weekly notice

Monday, 9 November 2026

RailSafe

Figure 1 Layout and instruction provided within Releasing Unit

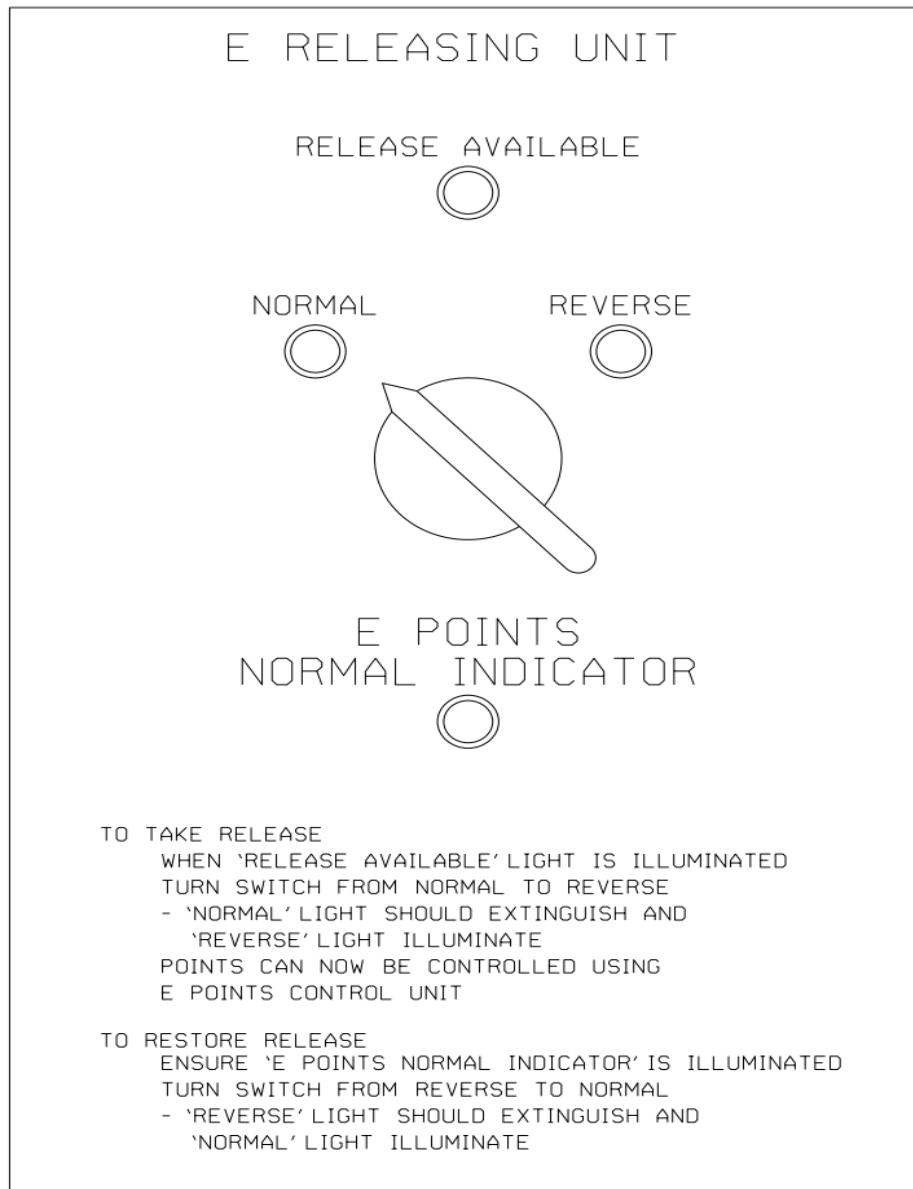
Instruction for operating E Releasing Unit:

- When 'Release Available' light is illuminated
- Turn switch from Normal to Reverse
 'Normal' light should extinguish and 'Reverse' light illuminate.
- Points can now be controlled using Control Unit.

Figure 2 Layout and instruction provided within Control Unit

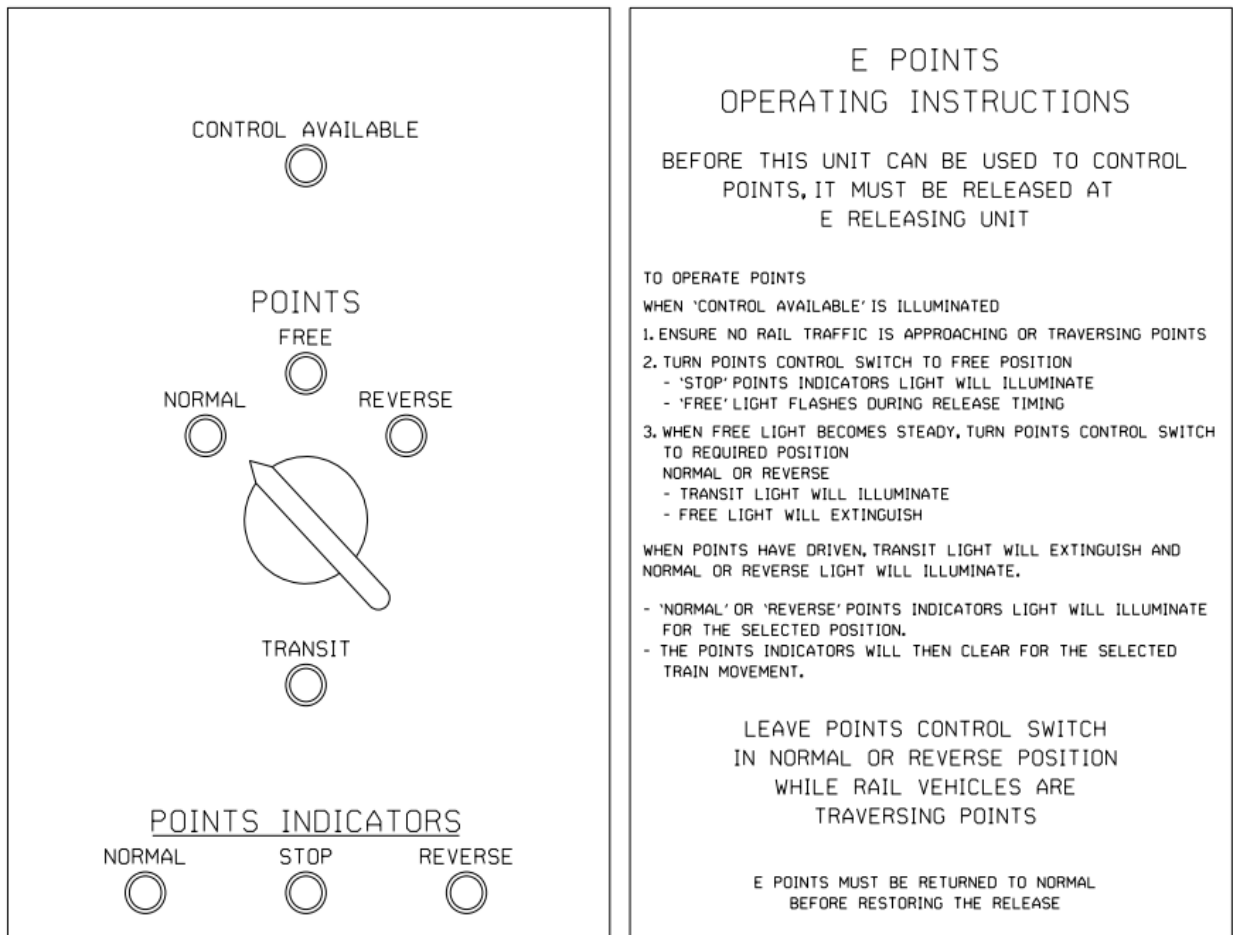
Points Control Unit - Operating instructions:

- When 'Control Available' is illuminated.
- Ensure no rail traffic is approaching or traversing Points.
- Turn Points control switch to Free position.
- 'Stop' Points Indicators light will illuminate
- 'Free' light flashes during release timing
- When 'Free' light becomes steady, turn Points control switch to required position Normal or Reverse
- 'Transit' light will illuminate

'Free' light will extinguish

- When Points have driven, 'Transit' light will extinguish, and 'Normal' or 'Reverse' light will illuminate.
- 'Normal' or 'Reverse' Points Indicators light will illuminate for the selected position.
- The Points Indicators will then clear for the selected train movement.
- Rail traffic can be authorised to traverse the points.
- Leave Points control switch in Normal or Reverse position while rail vehicles are traversing points.
- Points must be returned to Normal position before restoring the release.

Drivers Diagram VER30012026

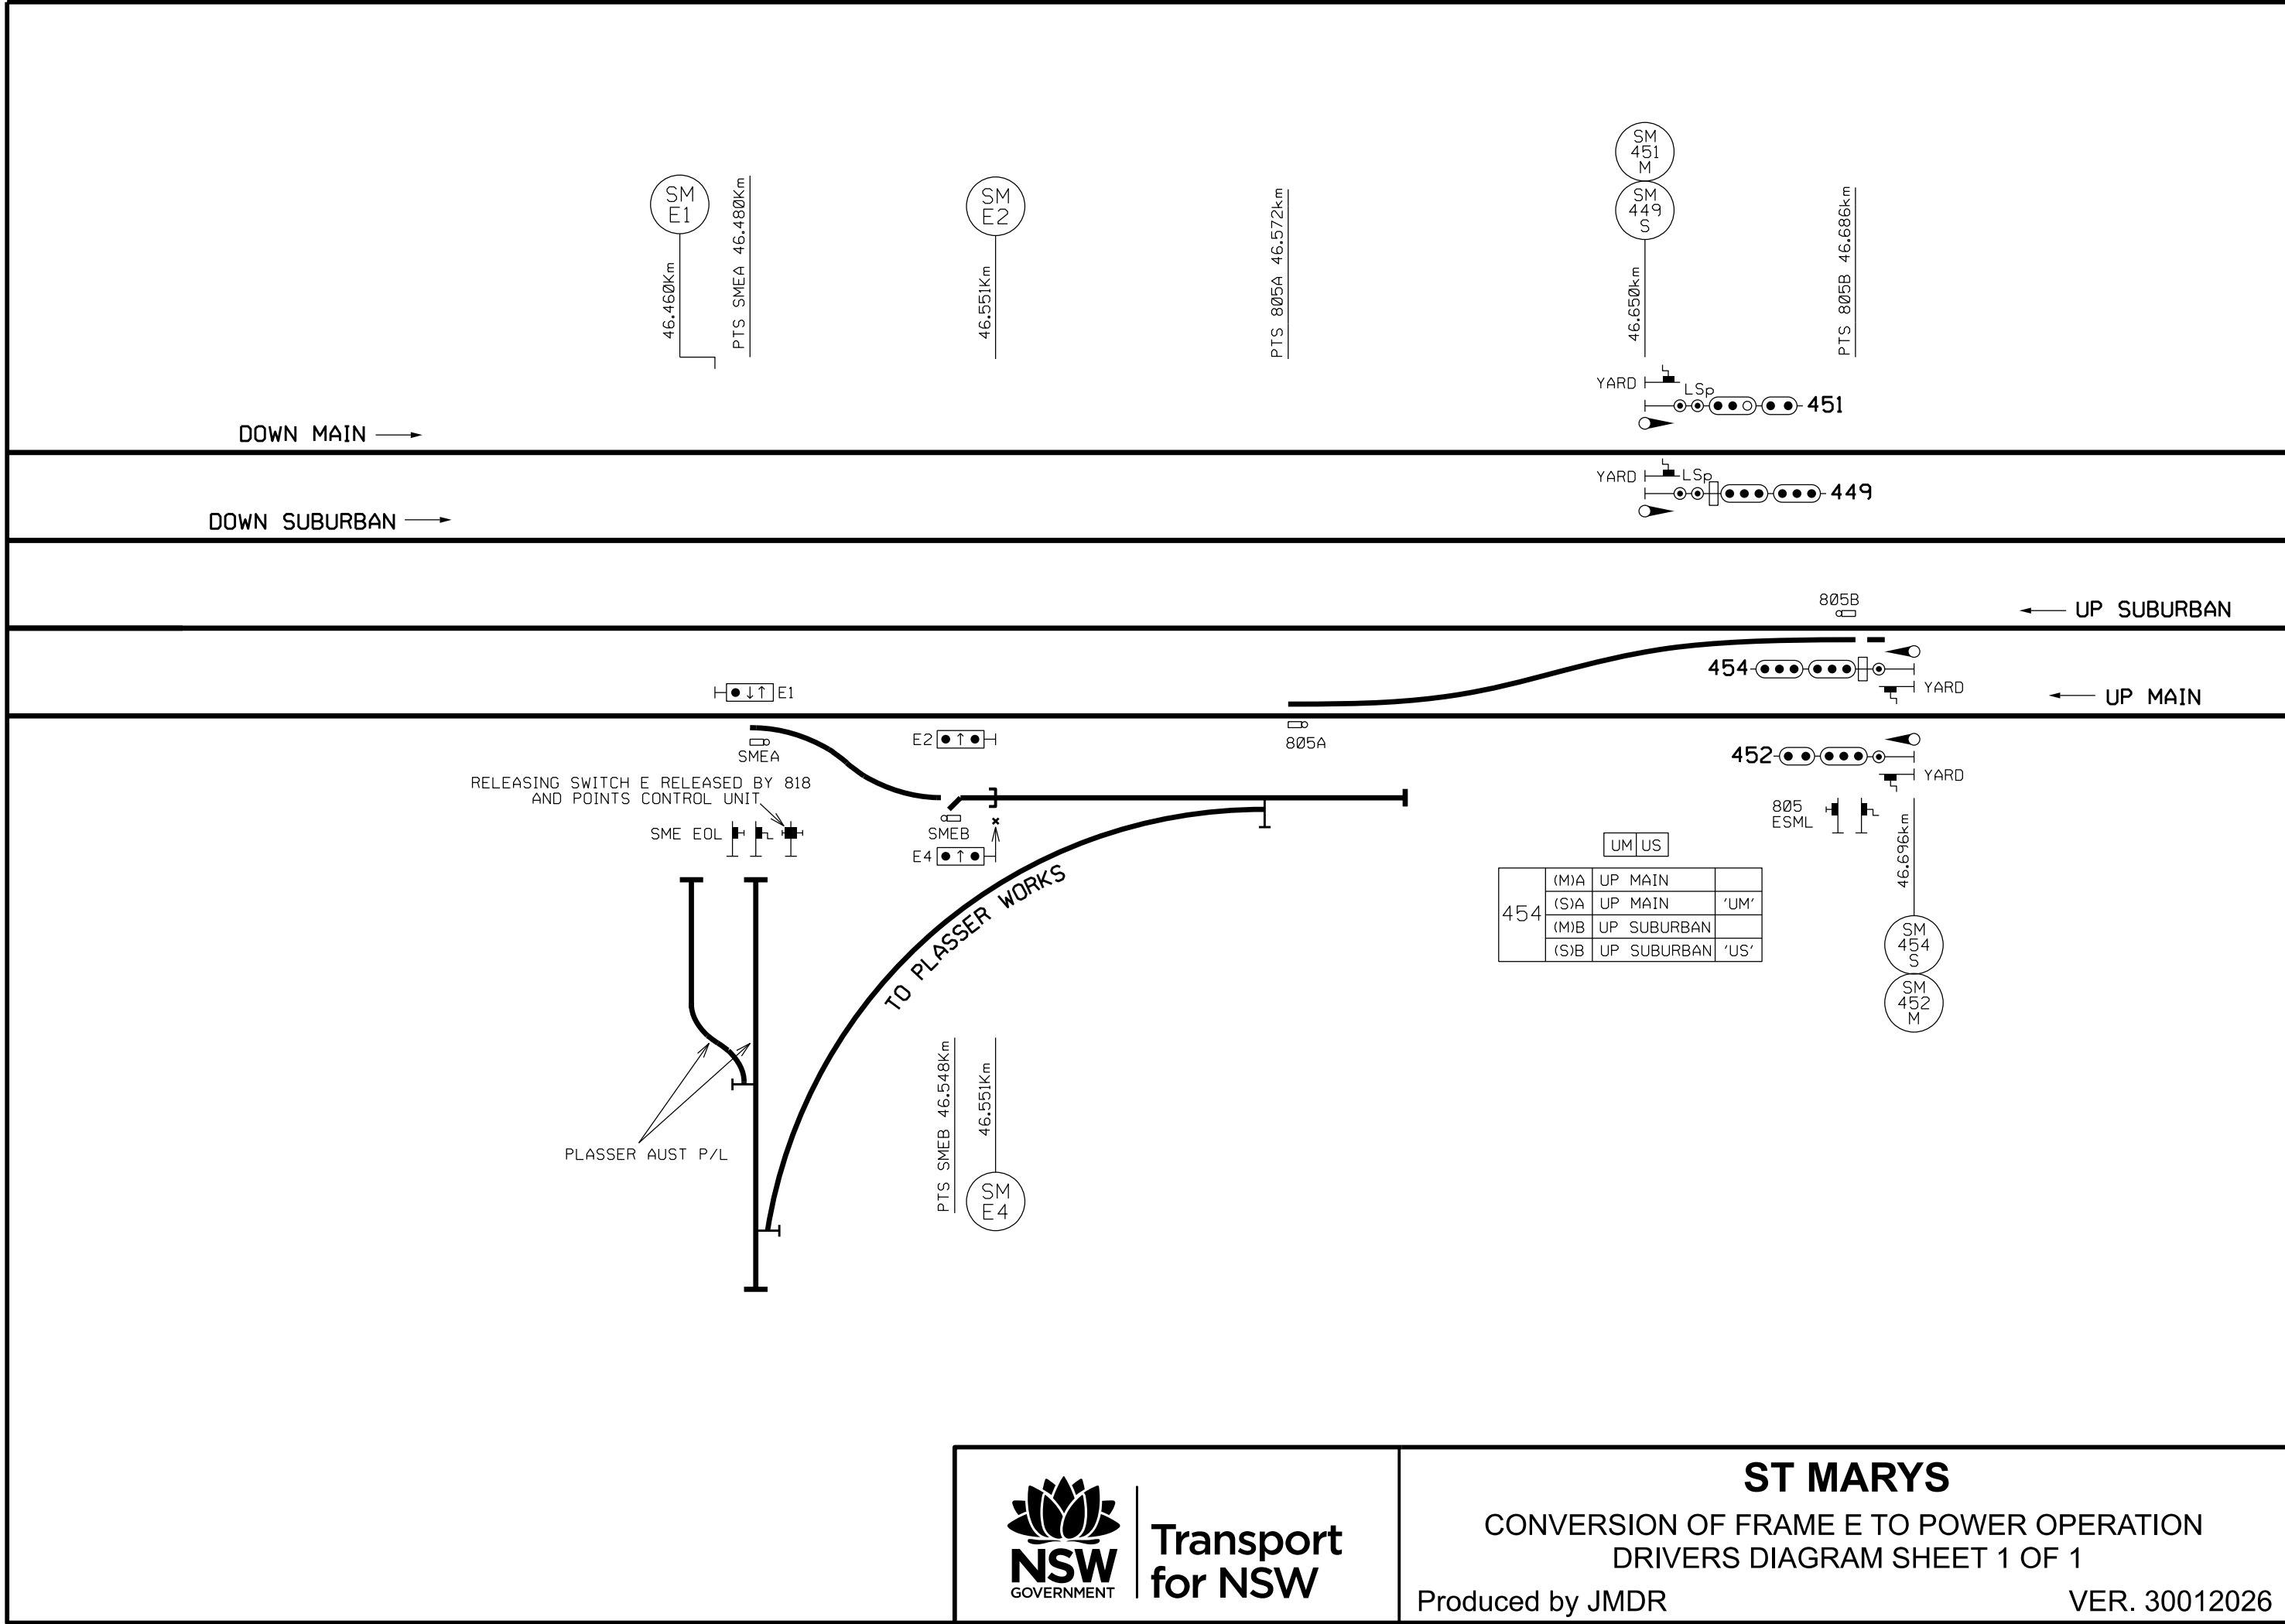
Upgrade of Frame E

- Lever E and its associated equipment will be removed.
- Releasing switch E will be removed.
- The existing catchpoint sign on the Plasser works siding will be removed.

- Frame E on the Up Main will be renewed and relocated approximately 2.924m towards Sydney and renamed as SMEA points.
- Frame E on the Plasser Works siding will be renewed and relocated approximately 0.798m towards country and renamed as SMEB points.

- SMEA & SMEB points will be fitted with a Siemens D84M MKIII point machine with an in-bearer Spherolock arrangement.
- New colour light points indicators SME1, SME2 and SME4 will be provided as shown on the included Drivers Diagram.

- New SME EOL will be installed near SME points and commissioned.
- A new post mounted E Releasing Unit and Points Control Unit will be installed for local operation of SME points. Instructions for operation are within the Releasing and Control Units.

- St Marys Control Panel will be altered.
